Project Name: Sheridan Rd – Bid Package 2 – New BuildProject No.: 221125-100Architect: KingscottDate: 07/31/2026Bid Package No.: 2Bid Due Date: 08/11/2026 @ 2:00PM

This Addendum is issued to inform the bidders of modifications in the scope of work being bid for this project.

END OF ADDENDUM NO. [#1]

SHEET NO. **S1.1**

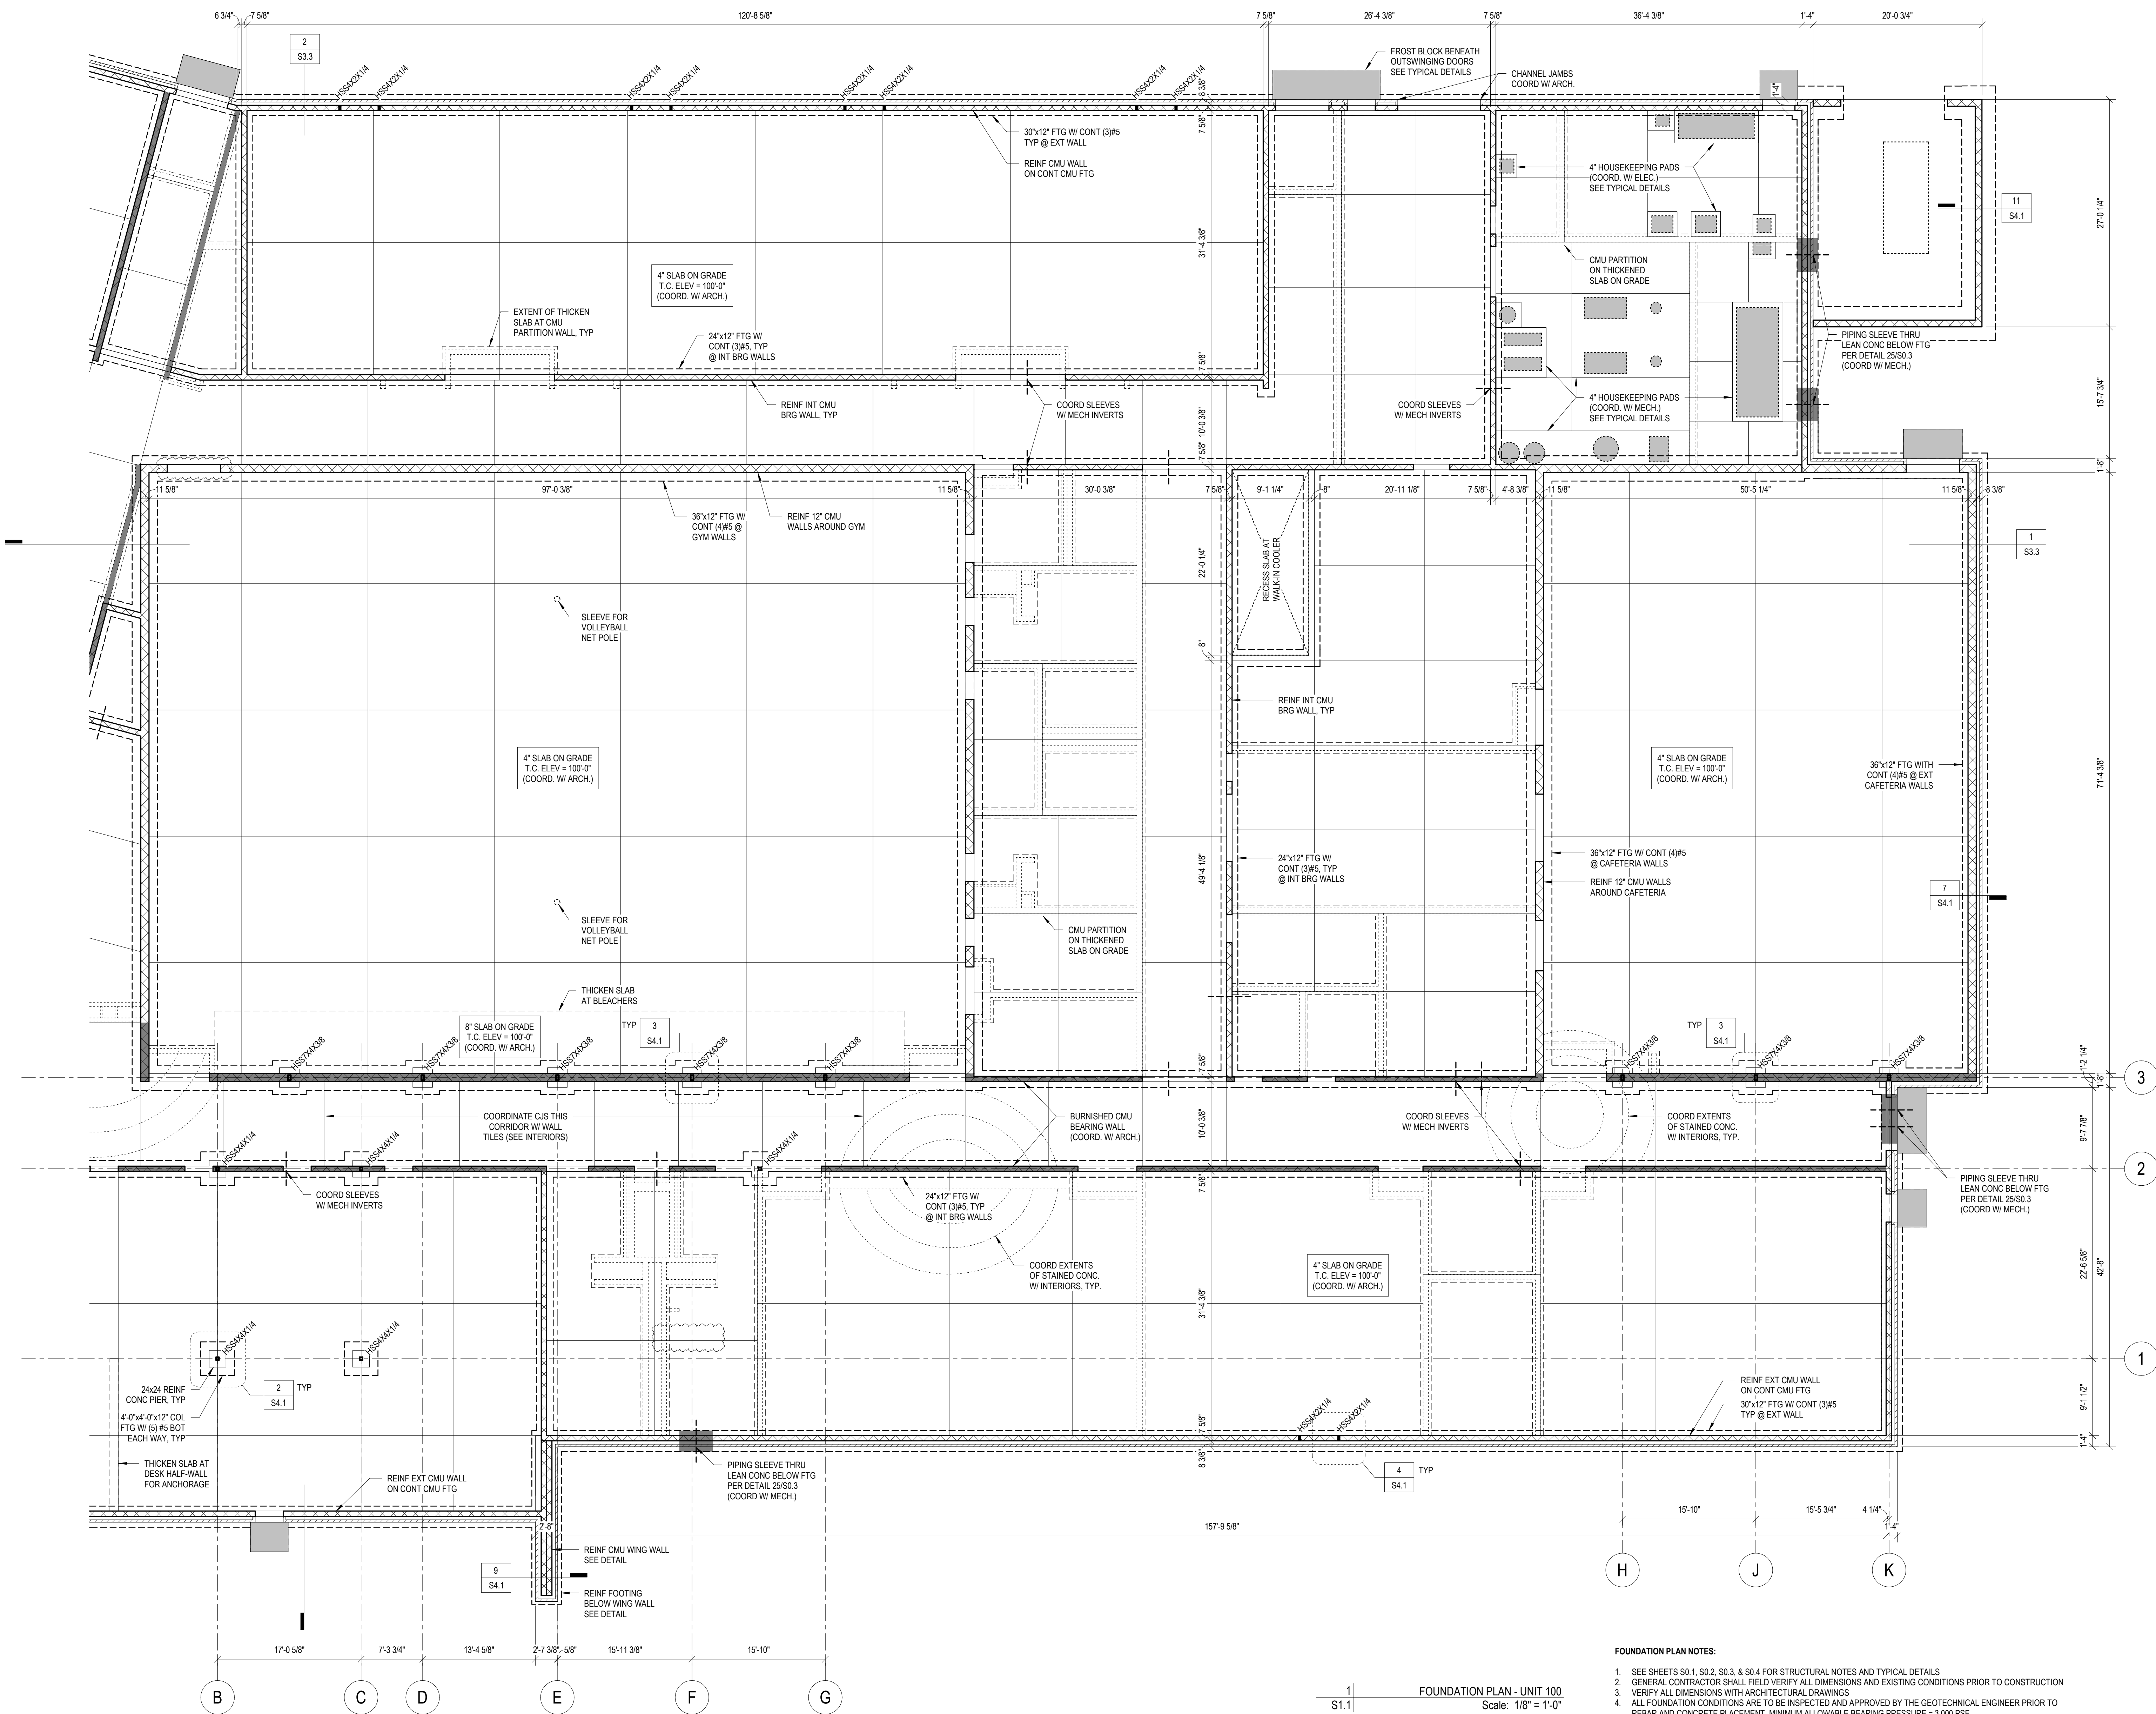
- 1/S1.1: Revise door opening at northwest gymnasium corner.
- 1/S1.1: Remove CMU partition and associated thickened slab at toilet room.

S1.2

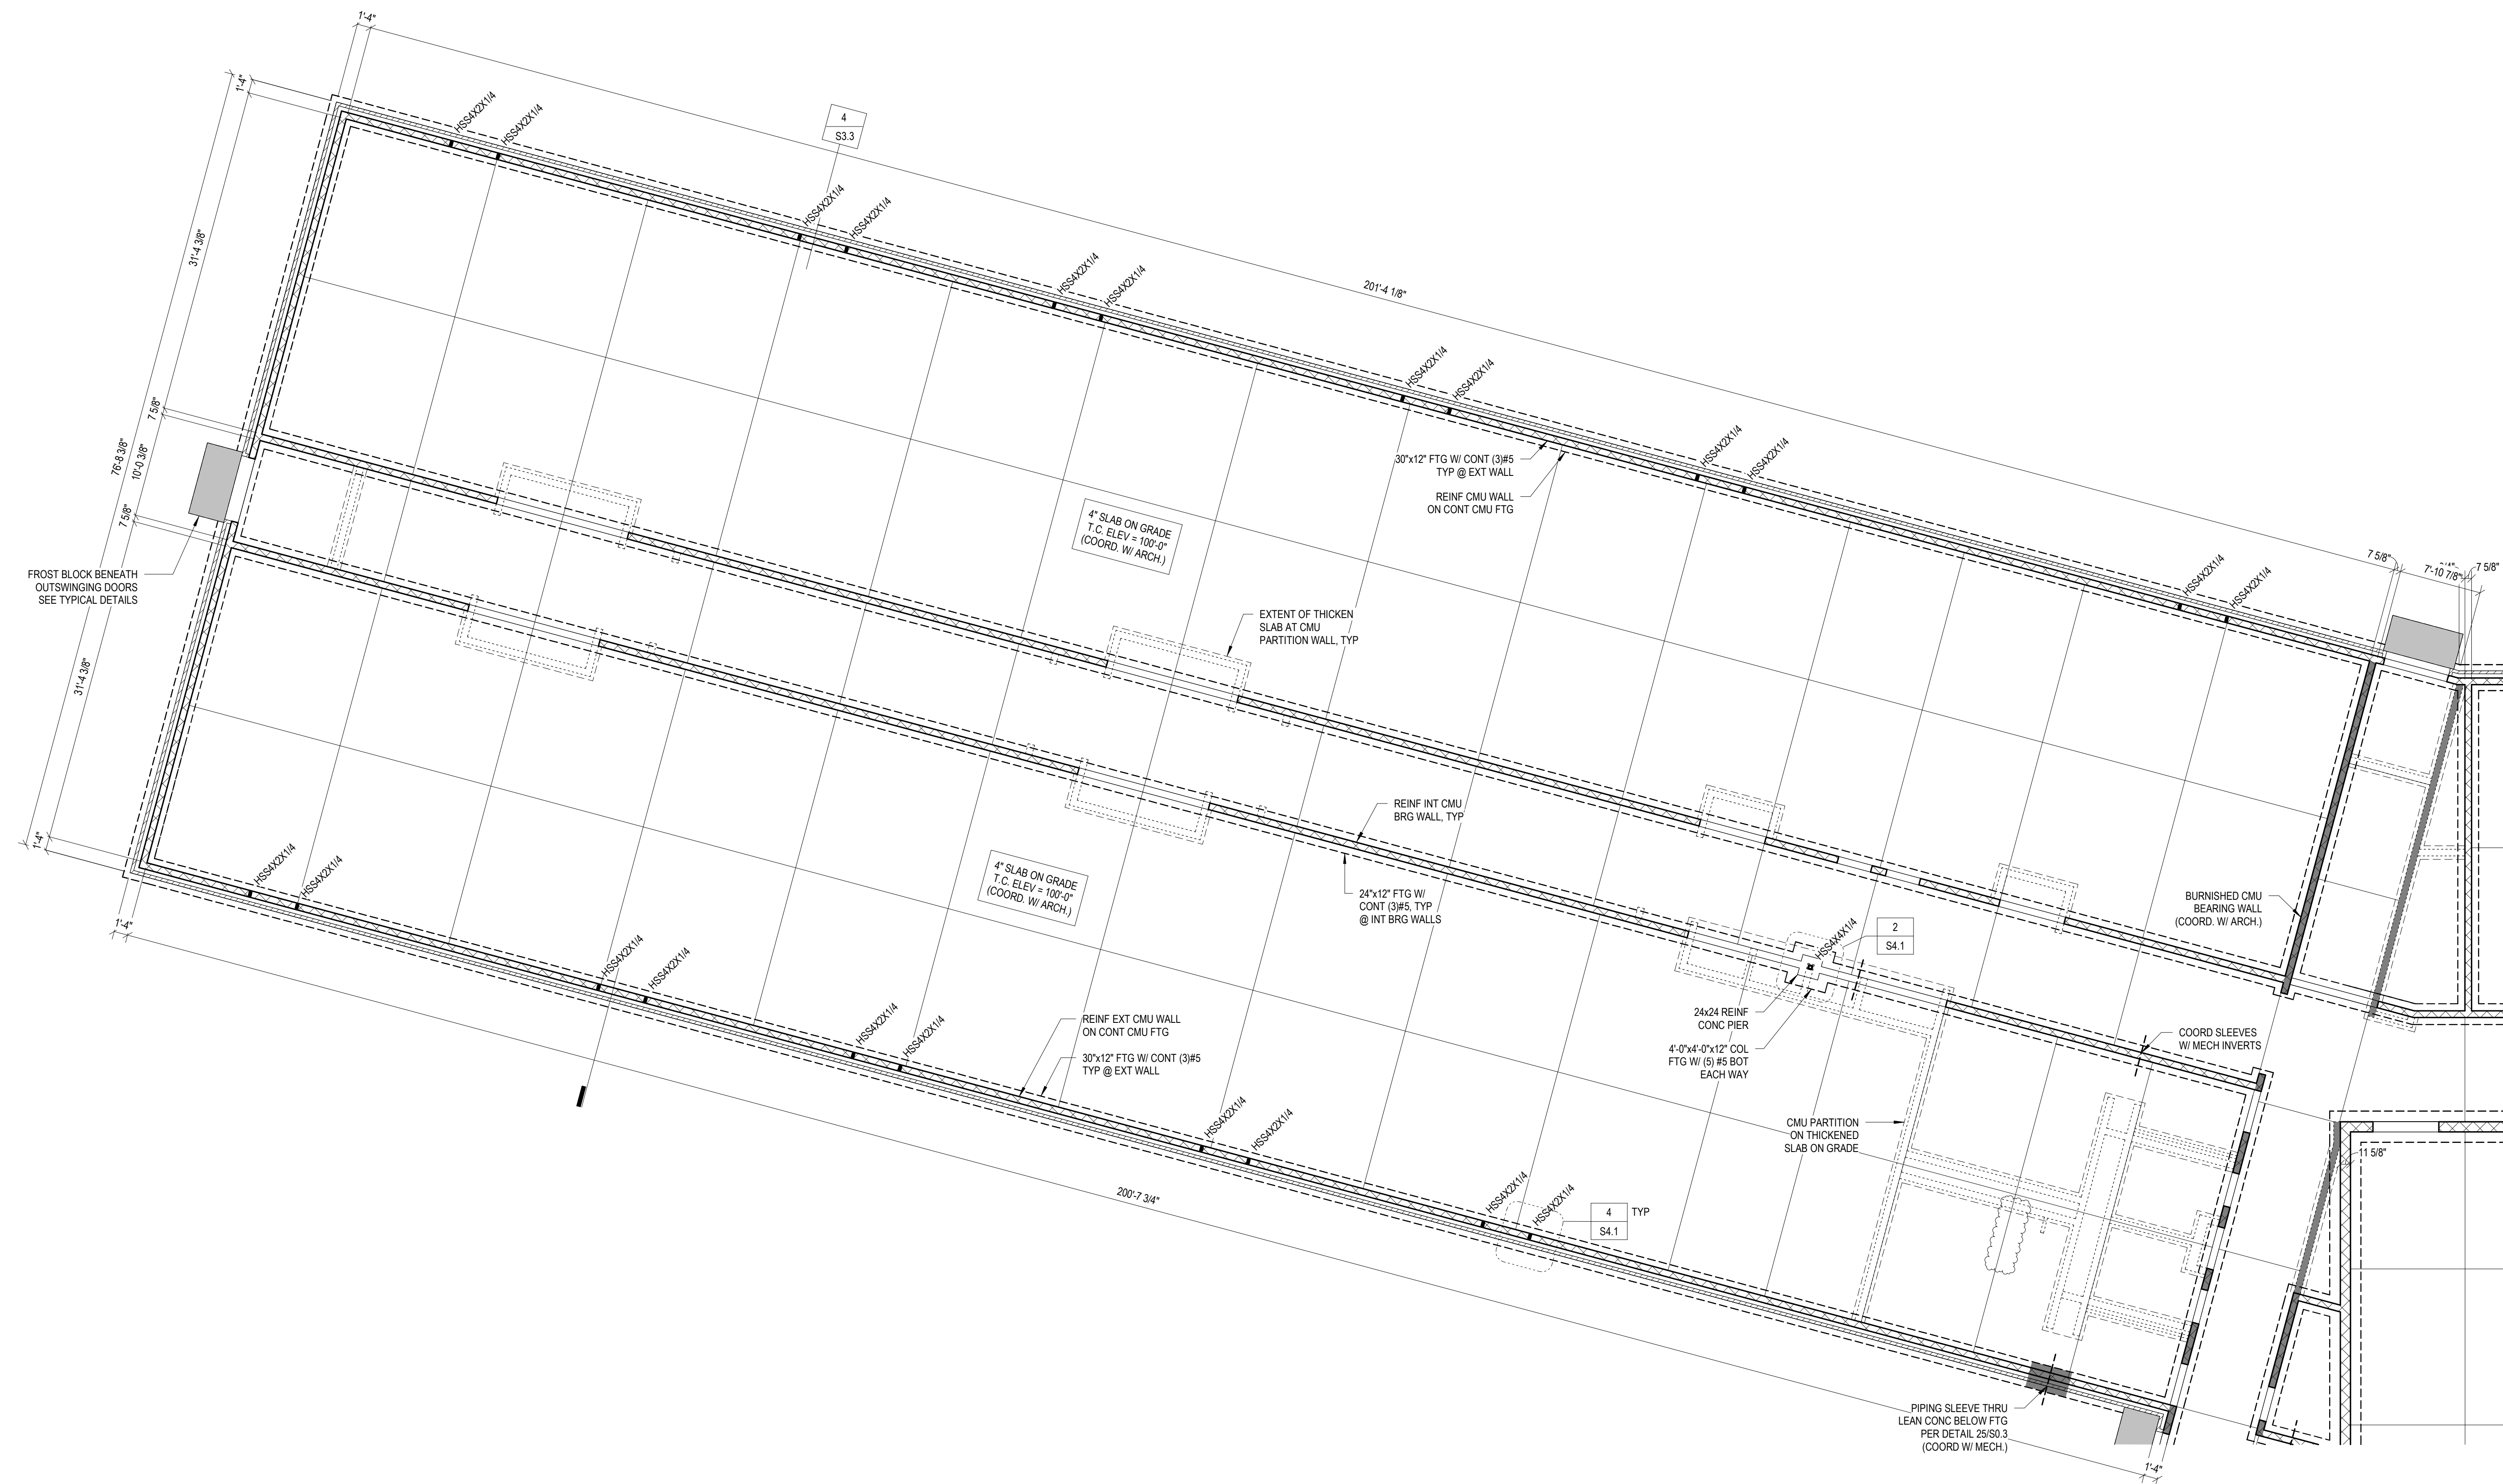
- 1/S1.2: Remove CMU partition and associated thickened slab at toilet room.

1 | FOUNDATION PLAN - UNIT 200 SOUTH
S1.3 | Scale: 1/8" = 1'-0"

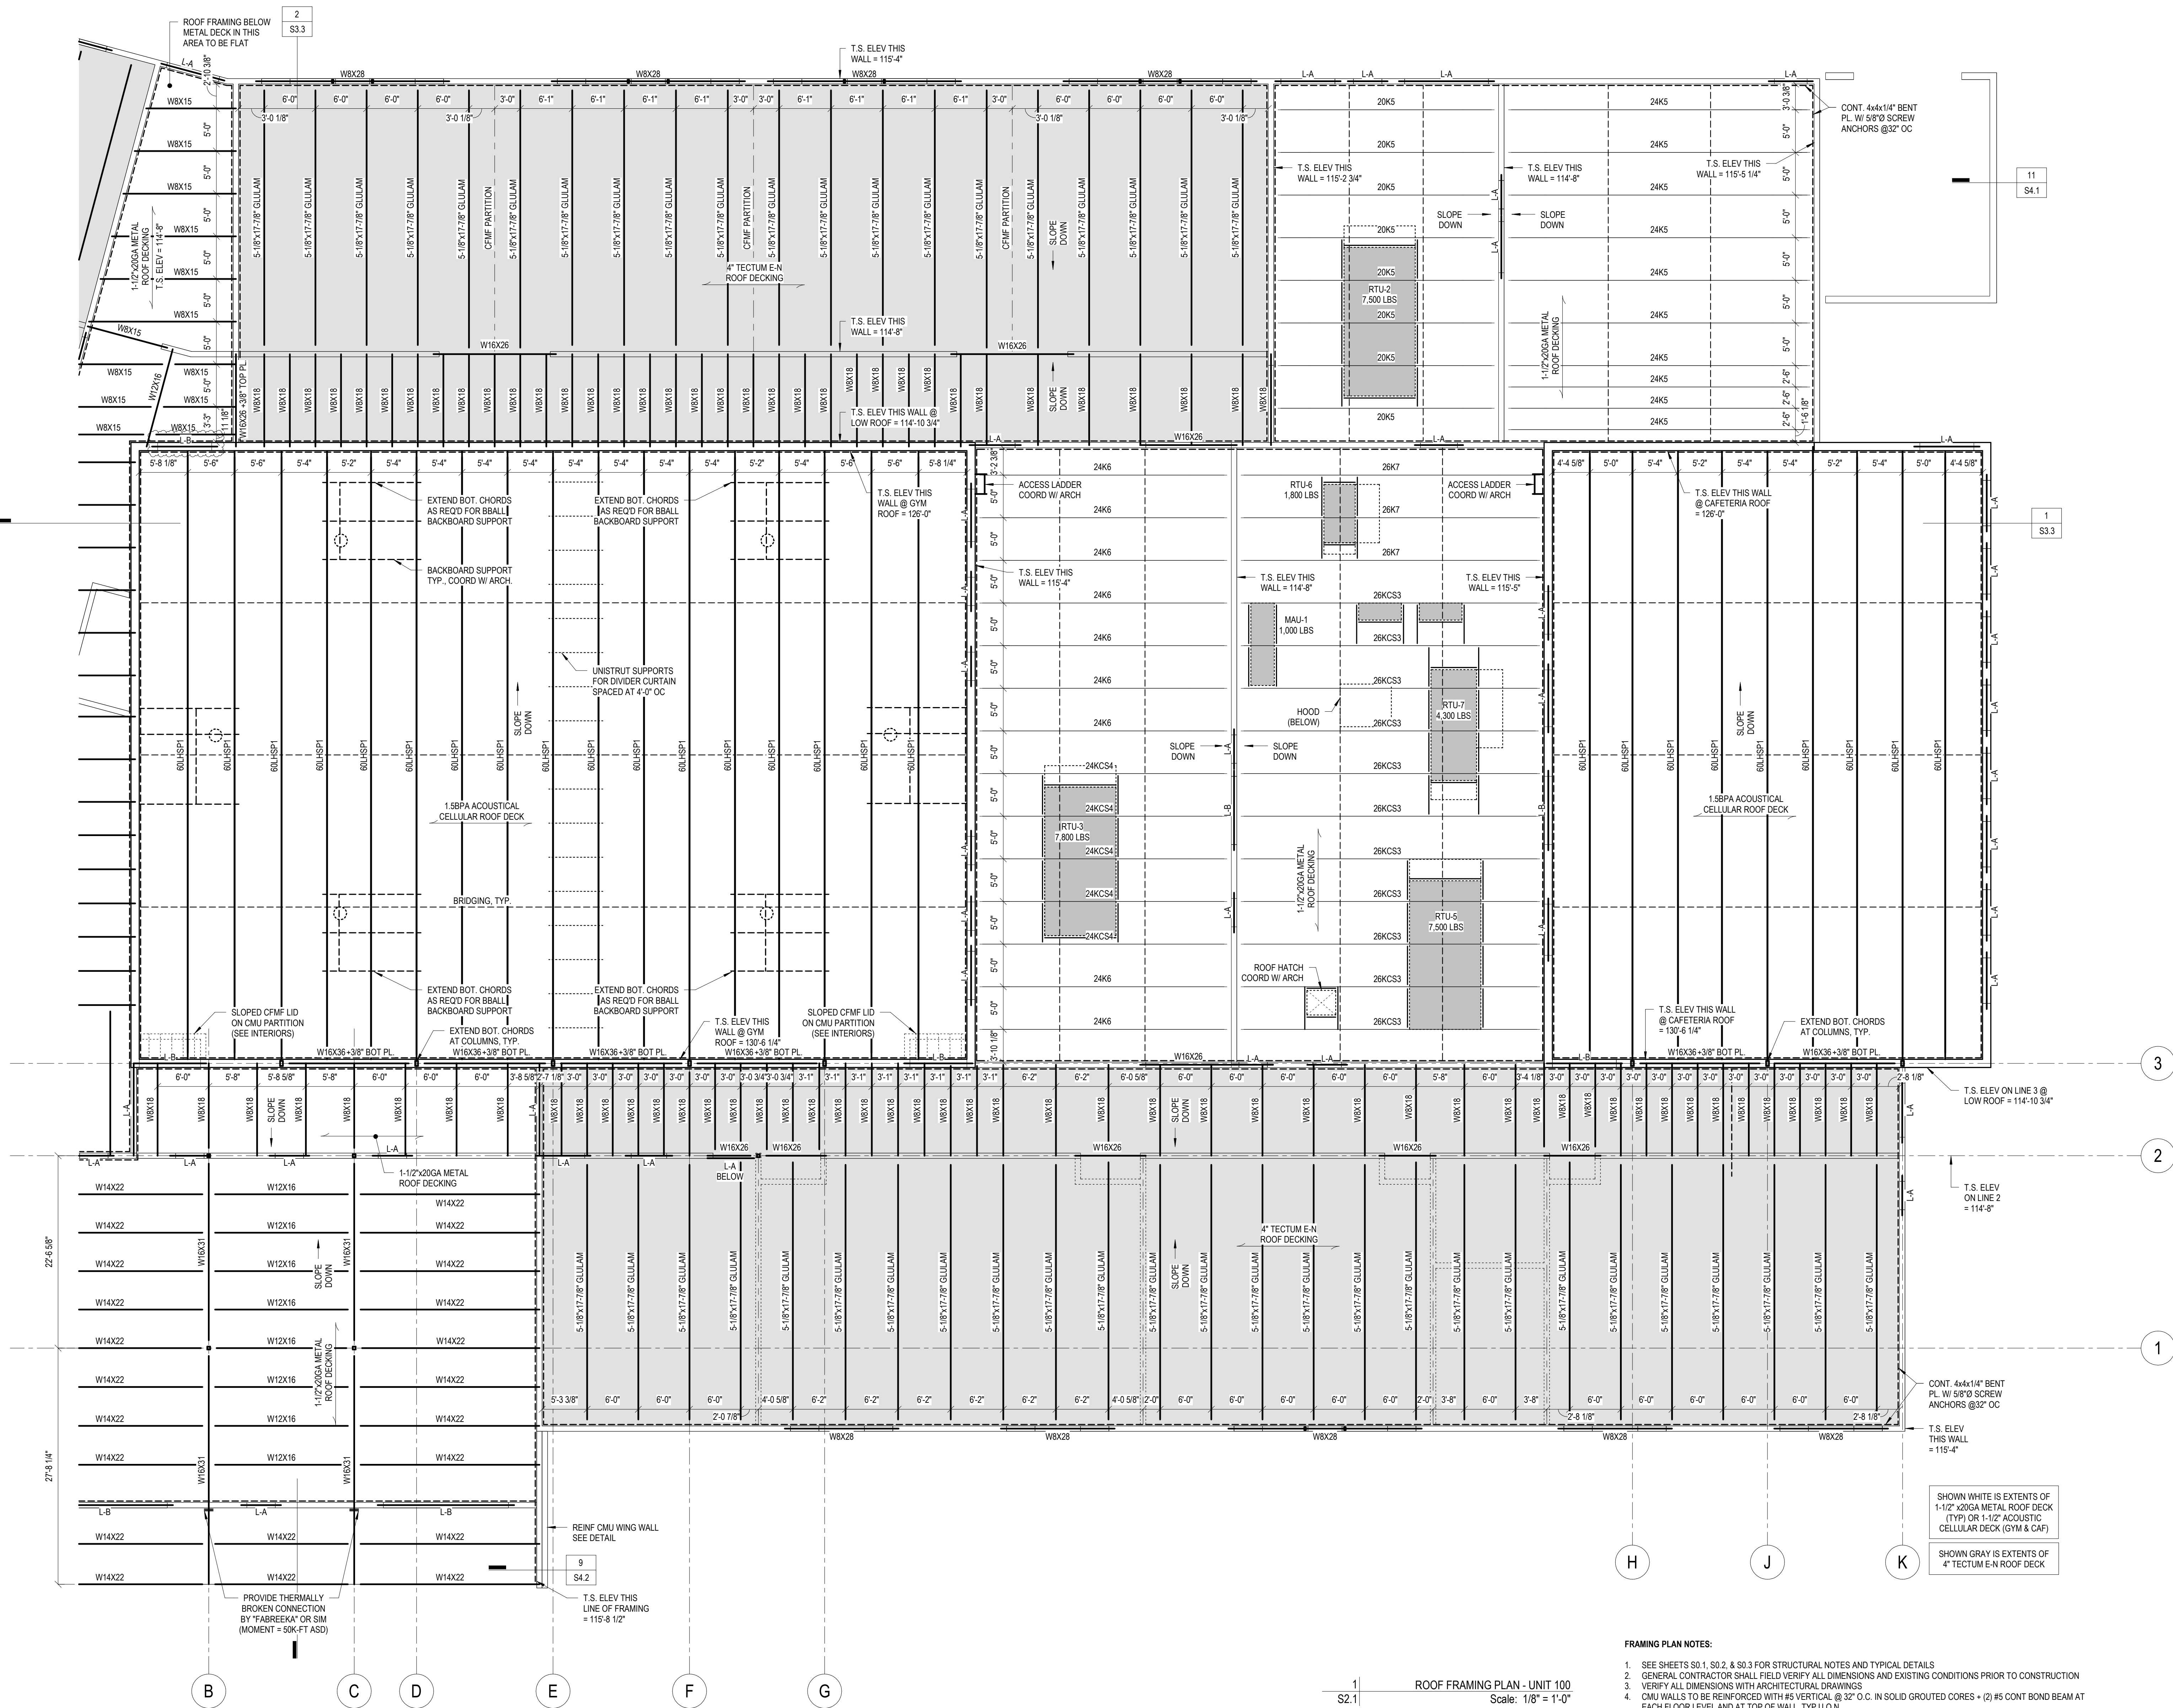
- 1/S1.3: Remove CMU partition and associated thickened slab at toilet room.
